2.0 RESPONSES TO COMMENTS

Subject: Eastside Aggregates Project
SCH#: 2000062079

Hat Creek Construction's Eastside Aggregate Reclamation Plan

Figure 4.8-3
Hat Creek Project Site, Approximate Locations of Proposed Project
Components and Nearest Residences

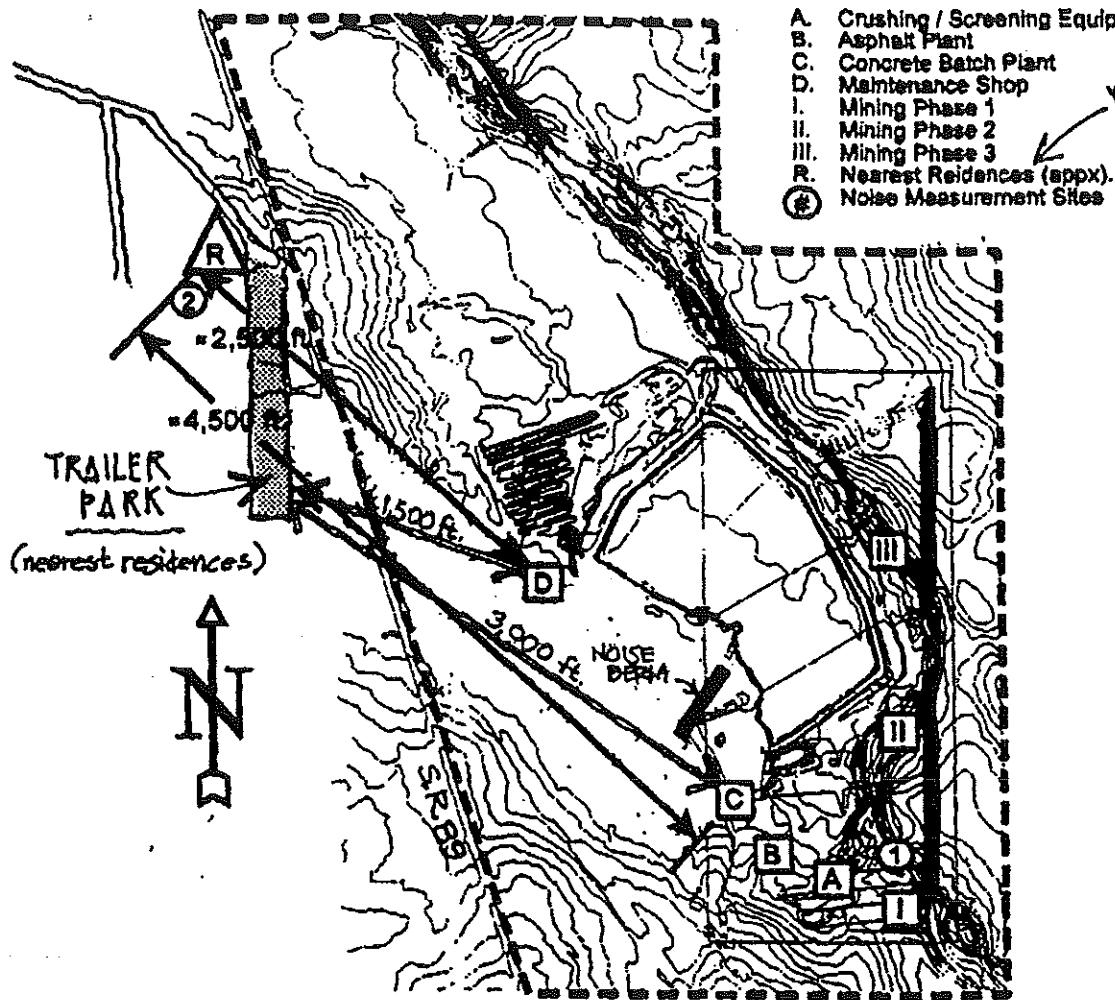
4.8-5	Figure 4.8-3	This needs to reflect the accurate location of nearest residence. What about the effect of any of this to the employees on the site?	11-133

The EIR's conclusions are entirely flawed because they are based on protecting homes that are not the closest to this Project. The EIR erroneously overlooks the nearest residences — trailer homes — that are even nearer to the Project area. The County's 1996 Initial Study for this Project, on page 13, stated that the trailer park and other residences would be about 3,200 feet from the proposed asphalt plant, not the 4,500 feet that the current EIR mistakenly uses. As shown on the accompanying modified drawing "Figure 4.8-3", these trailer homes are about only 3,000 feet from some of the stationary heavy equipment locations (concrete batch plant) and about 1,500 feet from the proposed truck repair facility. The noise levels at these trailers will be substantially louder since they are much closer than the EIR considers.

The statement that the EIR completely ignores the presence of the trailer park is incorrect. The "nearest residences" referred to in the DEIR were, in fact, the closest homes in the trailer park. The confusion surrounding this comment and other similar comments appears to be due to the identification of the nearest residences on Figure 4.8-1.

The nearest residence to the project site is Unit 18 of the trailer park. This is the residential location which was used in the assessment of noise impacts in the DEIR, and which was referred to as the nearest residence on Figure 4.8-1. Figure 4.8-1 of the DEIR does not clearly show the locations of the trailer park residences; so the triangle shown to represent those residences may not be precisely located on that figure. However, the distances to the nearest residence which were shown on that Figure are accurate, as they were scaled directly from an aerial photograph which clearly shows the location of the residence at Unit 18.
